PROJECT NAME: DIMOVSKI DUPLEXES 2024

PROJECT NUMBER: 2024070025

APPLICATION: MINOR SITE PLAN #31762

REVIEW ITEM: Minor Site Plan

MINOR SITE PLAN
 Scale: 3/32" = 1'-0"

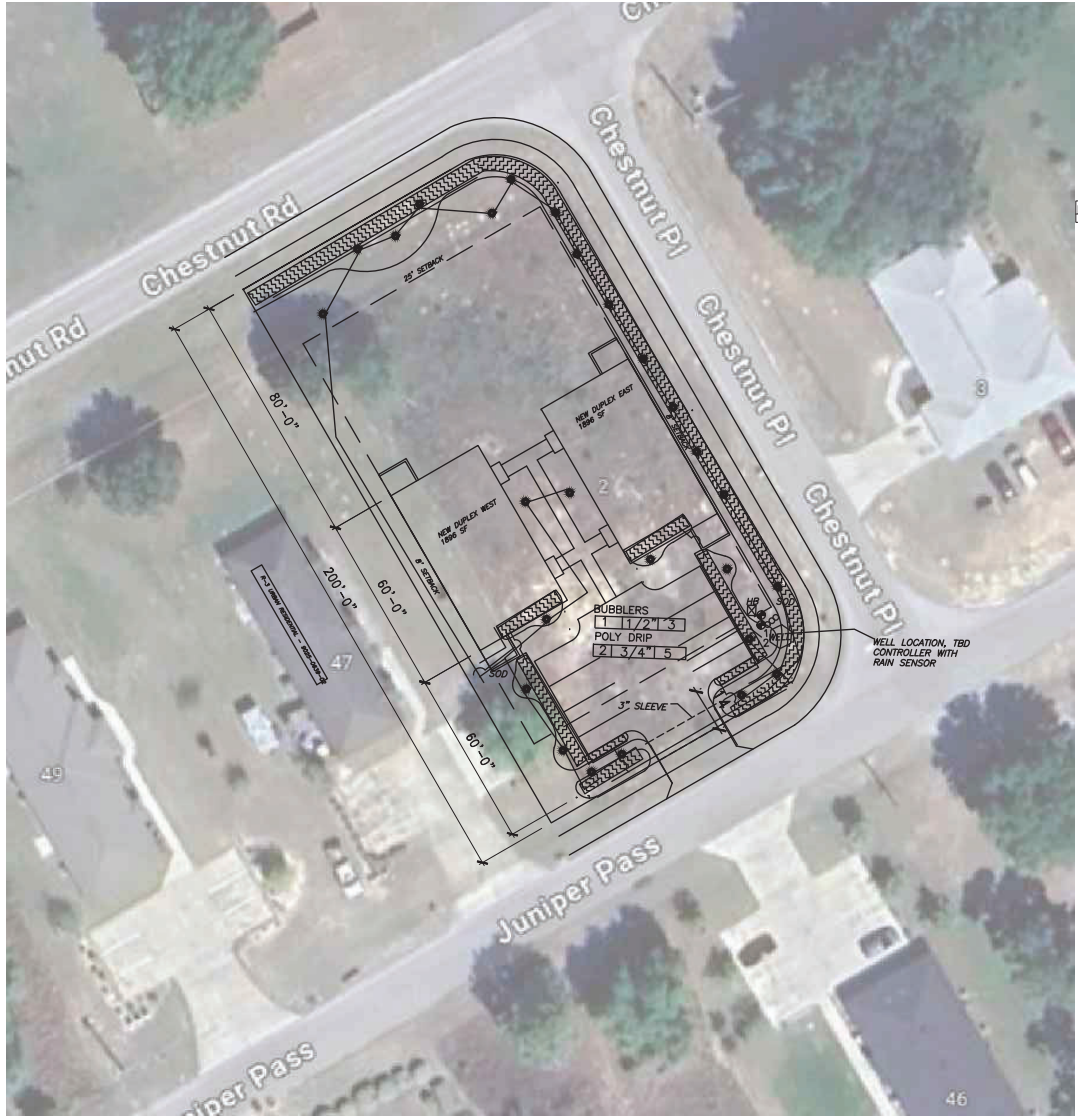
- 8 DEPARTMENT: ZONE - ZONING DEPARTMENT
REVIEW ITEM: 2.20.1.A - When any of the Minor Site Plan thresholds are exceeded, a Major Site Plan is required
STATUS OF REVIEW: INFO
REMARKS: 6972 sq ft impervious 34.1%

- 9 DEPARTMENT: ZONE - ZONING DEPARTMENT
REVIEW ITEM: 2.12.10- Show any known easements existing or proposed i.e. ingress or egress, landscape, or conservation
STATUS OF REVIEW: INFO
REMARKS: No easements called out.

- 10 DEPARTMENT: ZONE - ZONING DEPARTMENT
REVIEW ITEM: 2.12.27 - Show location of outside storage areas
STATUS OF REVIEW: INFO
REMARKS: None shown
- 11 DEPARTMENT: ZONE - ZONING DEPARTMENT
REVIEW ITEM: 2.12.21/6.3.1.C(10) - Land use and zoning on project and on adjacent properties shown
STATUS OF REVIEW: NO
REMARKS: Please show for subject property and adjacent properties on an aerial of the site and surrounding area.

- 12 DEPARTMENT: ZONE - ZONING DEPARTMENT
REVIEW ITEM: 2.12.32 - Modified environmental assessment or exemption if information is available to the county to indicate no habitat or existence of endangered species or vegetation (Article 6, Division 5, Sec. 6.5.4)
STATUS OF REVIEW: NO
REMARKS: An environmental assessment report or exemption must be provided.

- 13 DEPARTMENT: LSCAPE - LANDSCAPE DESIGN AND IRRIGATION
REVIEW ITEM: 2.12.18 - All trees 10" DBH and larger
STATUS OF REVIEW: NO
REMARKS: Plan states no existing trees, plan also shows two existing trees being preserved - please clarify - 2024 MCPA aerial does not show existing trees

- 14 DEPARTMENT: LSCAPE - LANDSCAPE DESIGN AND IRRIGATION
REVIEW ITEM: 6.7.4 - Shade tree requirements
STATUS OF REVIEW: NO
REMARKS: shade trees to be 3.5" cal. min, plans shows 3"

- 18 DEPARTMENT: LSCAPE - LANDSCAPE DESIGN AND IRRIGATION
REVIEW ITEM: 6.8.6 - Buffers
STATUS OF REVIEW: NO
REMARKS: 1. show required groundcovers in ALL buffers, Liriope is on schedule, show on plan and provide quantity. 2 Waiver required for buffer width reduction for south and east boundaries 3. Show ornamental trees in south buffer 4. area on se boundary is missing buffer, please provide. 5. East and south buffers do not meet 50% planted are requirements

- 19 DEPARTMENT: LSCAPE - LANDSCAPE DESIGN AND IRRIGATION
REVIEW ITEM: 6.19.3 - Outdoor lighting plan requirements
STATUS OF REVIEW: NO
REMARKS: will there be outdoor lighting? if so a photometric plan is required
